Re: K-4 Residence
7595 Hillside Drive
Project No. 522708

The applicant and project architect recently submitted to you revised drawings dated 5-1-2020. The applicant also submitted digital copies of six drawings (Sht. Nos. A.01, A-02, A-03, A-04, A-06 and A-06.1) from those drawings, to the La Jolla Community Planning Association (LJCPA) for it's review of the project. The following comments pertain to the six drawings dated 5-1-2020 submitted to the LJCPA.

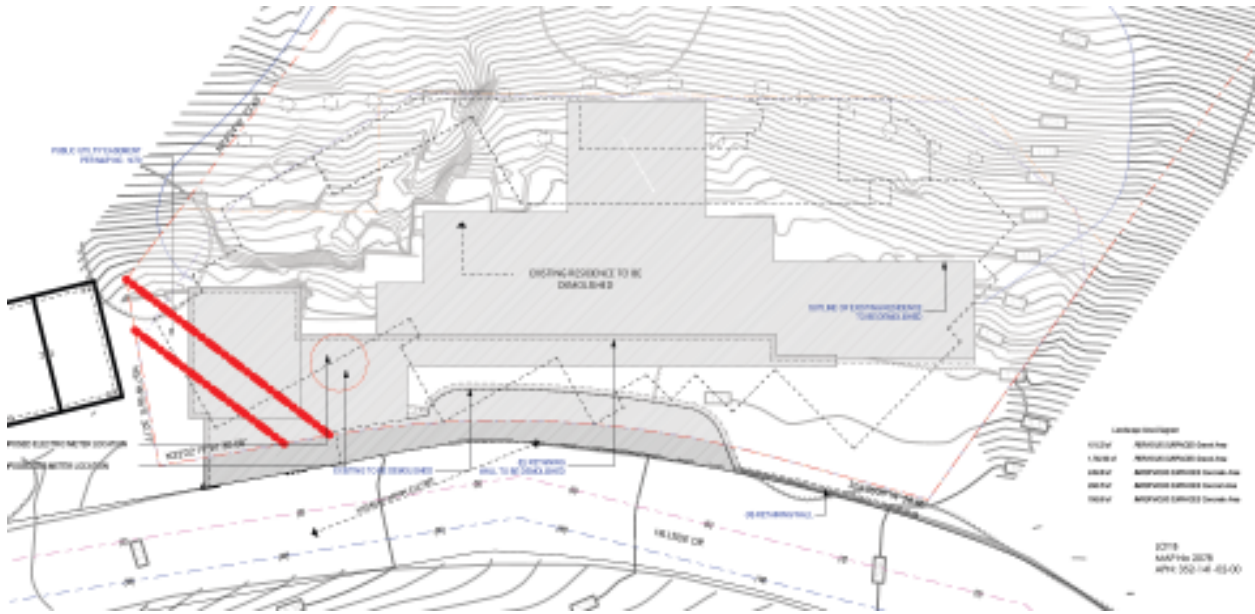
Contrary to the Parking Regulations SDMC Sec. 142.0521(f) the applicant still proposes a substandard driveway which fails to provide the required 30 foot minimum driveway length to accommodate off-street guest parking out of the public right-of-way, in addition to the elimination of two existing badly needed parallel out-of-the-roadway parking spaces on the narrow 19'-9" wide roadway, shown on the exhibit and aerial photo below:

Aerial view of the existing red brick paving out-of-the-roadway parallel parking spaces to be eliminated by the proposed design.

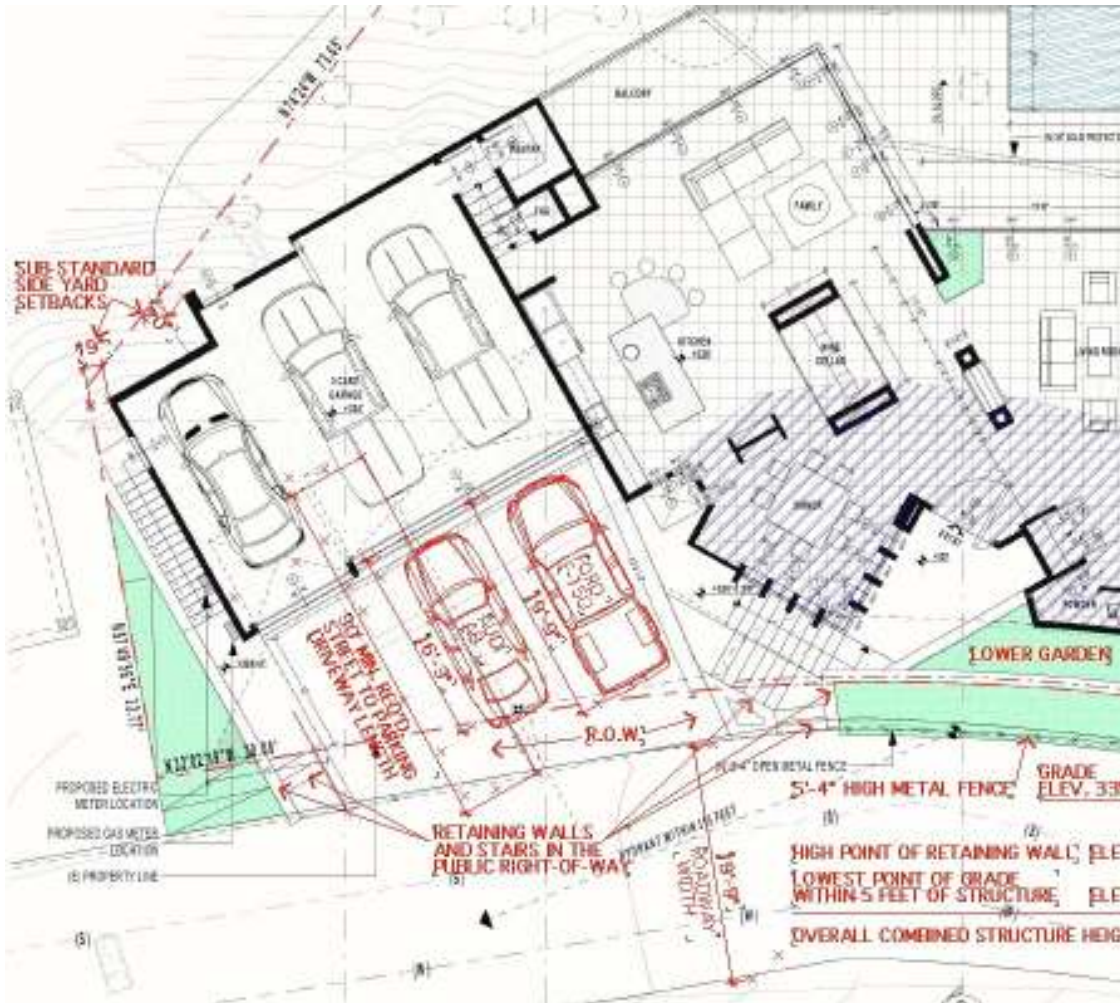
The following exhibit superimposes (in red) the revised location of the proposed garage door in relation to the street. The revised length of the proposed driveway is still well short of the minimum required 30 foot curb to garage door driveway length required by SDMC Sec. 142.0521(f). Portions of vehicles parked in the short sub-standard driveway will extend across the front property line into the street right-of-way.

A dimension line shows the 30 foot minimum street to garage door driveway length needed to comply with SDMC Sec. 142.0521(f) diagram 142-05A when no additional on-site parking is provided.

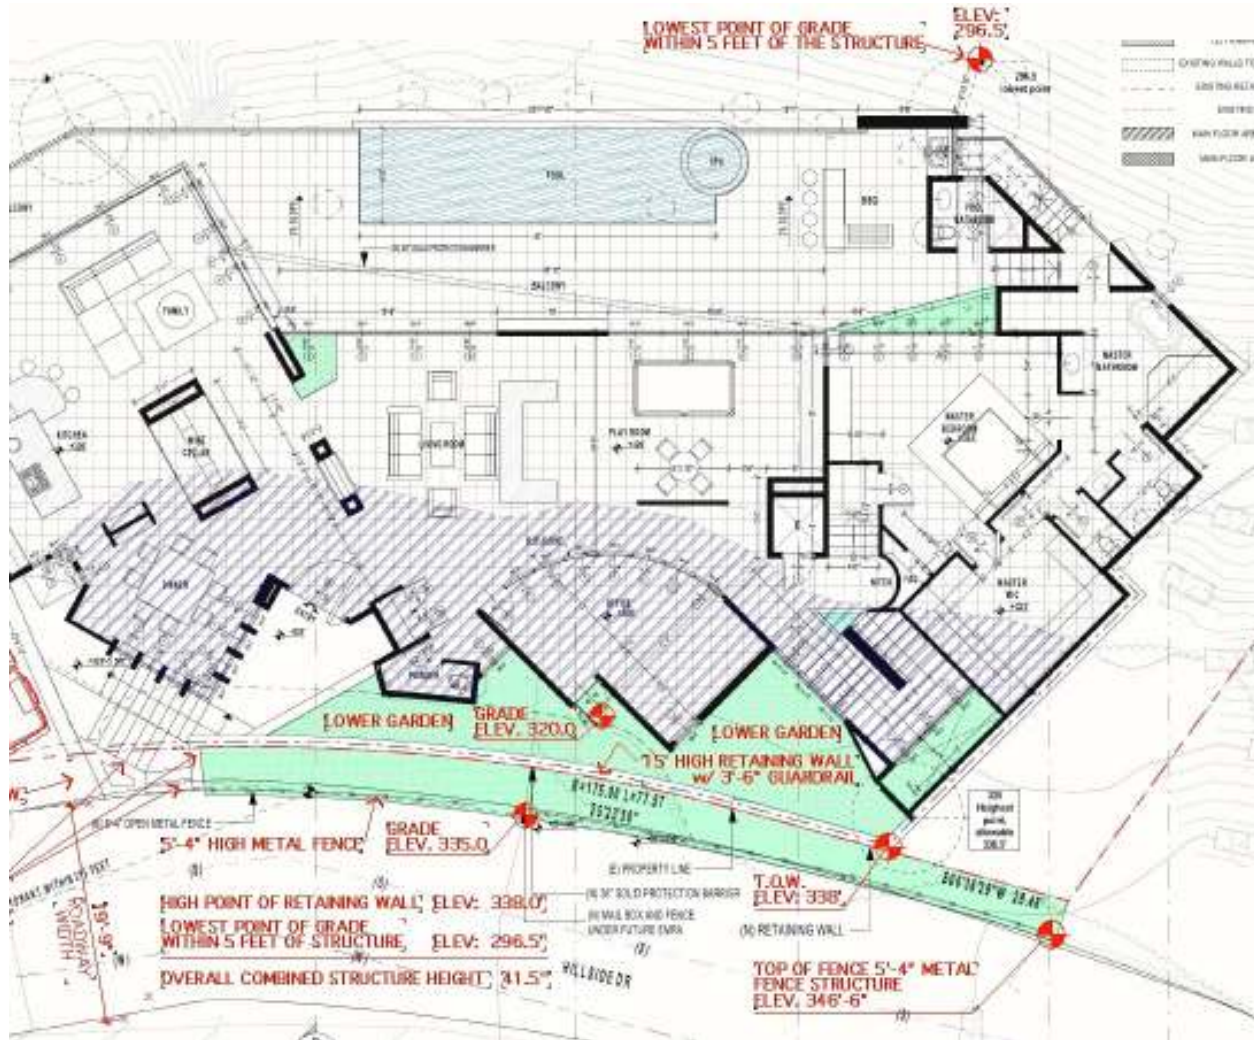
Looking West (downhill) on Hillside Drive. The temporary construction fence obscures the two existing and required out-of-the-roadway parallel parking spaces.

Looking East (uphill) on Hillside Drive toward the proposed project. The existing out-of-the-roadway parallel parking spaces in the foreground are in front of the adjacent property at 7605 Hillside Drive. The subject property is in the distance behind the green construction fence.
